Response to the Reviewers' Comments

The authors would like to thank the reviewers for the precious comments and suggestions on the technical contents and presentation of our manuscript “Runtime Power Management of Battery Electric Vehicles for Extended Range with Consideration of Driving Time,” submitted to IEEE Transactions on Very Large Scale Integration (TVLSI.) This revised manuscript has been greatly improved thanks to the reviewers’ invaluable advices. We have revised the manuscript faithfully following the reviewers’s comments. We include the newly added or significantly modified parts in the revised version of the paper also in Response to Reviewers. We highlight the important technical content changes and set those parts in a red color in the revised paper.

Fig. 2: (a) Range-speed experimental data for Chevrolet Bolt [36] and (b) comparison with simulation results of the proposed EV power model.

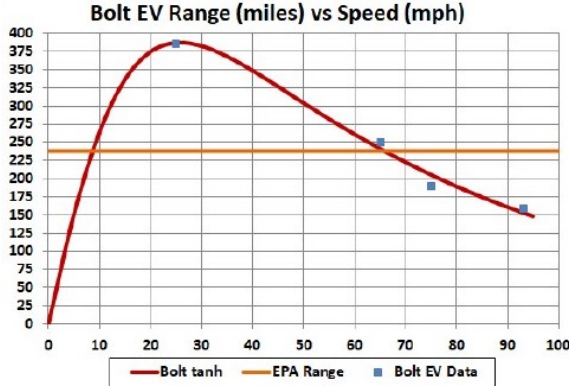
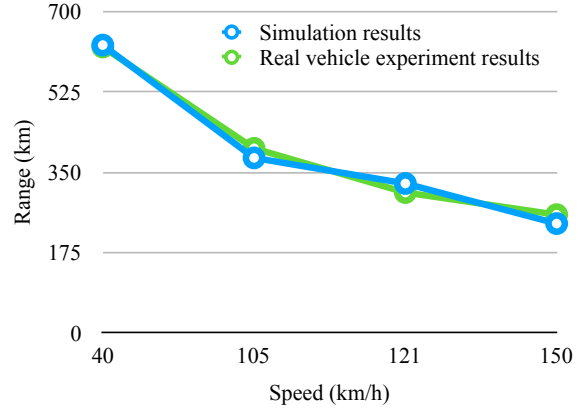
R1-C2 It is not clear how to validate the power model of EV. As the author mentions that accuracy of power model is quite important, it is good to see the power model in this paper can be validated by some real measurement results.

We use ADVISOR to extract the model coefficients of new vehicles starting from known vehicle specifications such as the aerodynamic resistance, rolling resistance, curb weight, and so on. Such data is often published in the users' manual, website and so forth. We further use the vehicle performance data such as the top speed, maximum acceleration, and so on, which are also available on the manuals, commercials and websites. We iteratively run ADVISOR and derive the model coefficients so that all the known data values match among each other. The model coefficient extraction result shows as in Fig. 1. The normalized root-mean-square (RMS) deviation is 5.1%. Table I summarizes the model coefficients of (5) for Chevrolet Bolt.

We further evaluate the model accuracy with the range-speed real vehicle experiments as shown in Fig. 2(a) to confirm the derived power models are close enough to the real vehicle measurement data [32], [33], [34], [35], [36]. We refine the coefficients until all the available data values match well.

As a result, the derived EV power model well matches with the range-speed experimental data as shown in Fig. 2(b) as well as the top speed and maximum acceleration setting the aerodynamic resistance, rolling resistance, curb weight, etc. with the known values. The errors in the range-speed simulation is merely 1.4%, the time for 0-to-100 km/h error is 7.8%, and the top speed error is 3.0%, respectively.

Fig. 12: Velocity profile comparison with EDP , E^2DP and E^3DP on Serrano Avenue in Anaheim Hills.

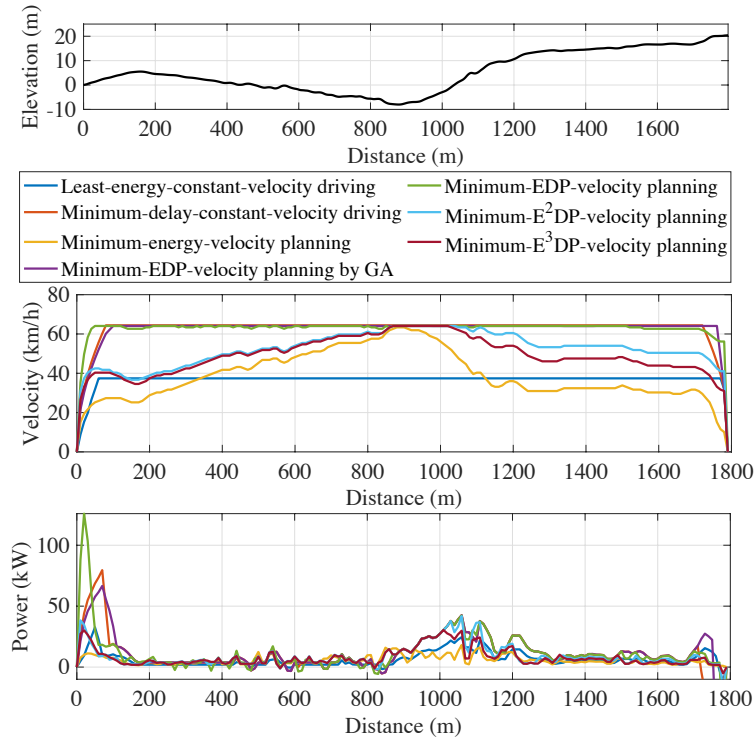
R1-C3 The optimality of the proposed scheduling algorithm is unclear. The author should add several paragraphs to discuss this topic. It is also to see the comparison baseline is well accepted to show the advantage of the proposed algorithm.

As the proposed solutions for EDP -, E^2DP - and E^3DP -aware-velocity planning are not optimal, we perform validation how close the proposed heuristics method is to the true optimal, comparing with the results of GA. We use the GA results as a golden reference to evaluate the optimality of the proposed heuristics. We divide a given driving route into multiple segments so that the solution of GA indicates a set of velocity values for each segment. We apply the vehicle acceleration and deceleration constraints so that the velocity difference at the boundary of two adjacent segments becomes close enough to avoid a jerky motion. We update the solution through crossover and mutation processes until the solution converges.

Fig. 12 summarizes EDP of the least-energy-constant-velocity driving, the minimum-delay-constant-velocity driving, the minimum-energy-velocity planning, the velocity planning with EDP , E^2DP and E^3DP as a metric on the road benchmarks and the minimum- EDP -velocity planning with GA. The proposed velocity planning results in up to 46.2% improvements of EDP compared with the least-energy-constant-velocity driving. The driving velocity on a flat road is faster than that of the least-energy-constant-velocity driving at the expense of relatively little energy to save driving time. Then, the velocity decreases when climbing the following uphill to spend less motor torque, which saves more energy.

In addition, EDP of the proposed EDP-aware-velocity planning is merely 4.3% higher than that of the true EDP-minimum-velocity planning on average. Through this results, we confirm that the results of the proposed heuristics are close enough to the true optimal solutions.

Fig. 11: Histograms of velocity and acceleration for the proposed energy-aware-velocity planning methods without an acceleration constraint (a) and (b) and with an acceleration constraint (c) and (d), respectively.

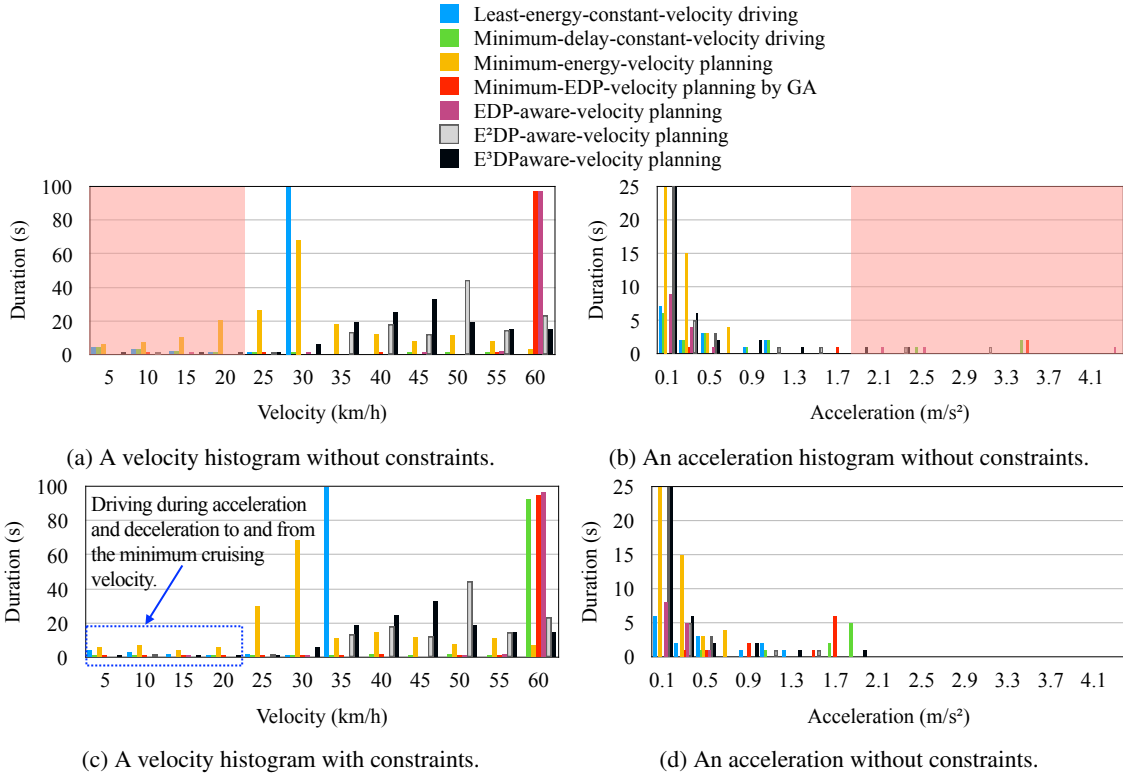
R2-C2 It would be good to have more discussion on the assumptions of the approach and the experiments, e.g., how much can the velocity be changed in practical scenarios without impeding traffic and causing unsafe situations (also depending on the road conditions and whether it is urban or rural environment I suppose). Currently, there only seems to be one constraint on not slower than 10 km/h.

We quantize the velocity and acceleration values and make a histogram to analyze population of velocity and acceleration for the proposed energy-aware-velocity planning methods. Fig. 11(a) and (b) show two histograms of the driving schemes in Fig. 12, which do not have velocity and acceleration constraints. We avoid a cruising velocity lower than 25 km/h and an acceleration higher than 2.0 m/s^2 in this paper without loss of generality. The acceleration of 2.0 m/s^2 is the same as the maximum acceleration of compact cars designed to be used primarily used in urban areas (13 seconds of 0 to 100 km/h time).

Fig. 11(c) and (d) shows the velocity and acceleration histograms with the constraints. Once we run the DP for the first time without constraints, we analyze the histogram, adaptively determine the minimum cruising velocity and maximum acceleration constraints, and run DP again. We keep the same constraints for online recomputation whenever unexpected interrupts occurs.

We also enforce the minimum acceleration not lower than 1.0 m/s^2 when the EV starts from a stop sign or a traffic light until the velocity reaches to the minimum cruising velocity not to bother traffic flow. The acceleration of a 1.0 m/s^2 exhibits 6 second delay to reach 25 km/h. The maximum speed is bounded by the speed limit of each road benchmark.

Fig. 8: Altitude changes in the real road benchmarks.

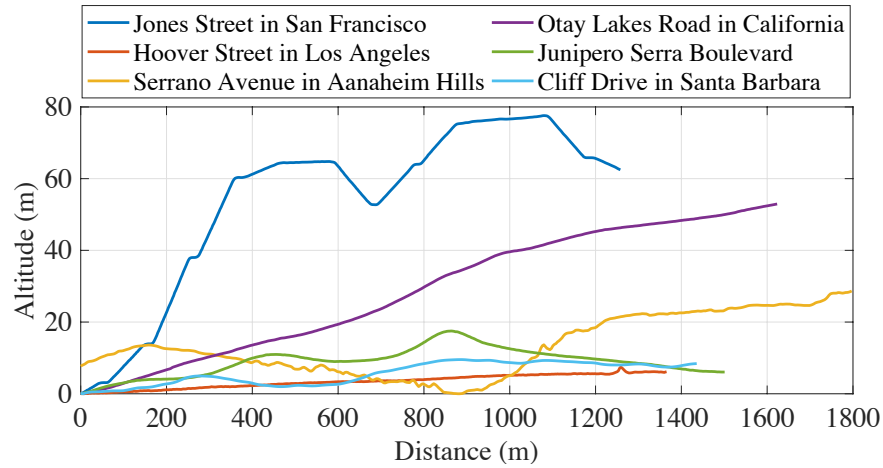
R2-C3 Related to the last point, it would be good to have more discussion on the road benchmarks, e.g., how they are generated and how representative they are. The optimization results significantly depend on road slope. It would be good to use a variety of real road segments for testing.

We choose six roads from various locations in California and make real road benchmarks. The first three roads are in cities. Jones Street in San Francisco and Hoover Street in Los Angeles are two representative city landscapes such as hills and flat roads, respectively, and Cliff Drive in Santa Barbara is a mixture of those. The second two roads are in mountain areas: Serrano Avenue in Anaheim Hills and Otay Lakes Road in San Ysidro Mountain in California. The last road is Junipero Serra Boulevard connecting San Francisco and San Jose. The details of road data is summarized in Table II, and Fig. 8, which visualize the altitudes of the road benchmarks.
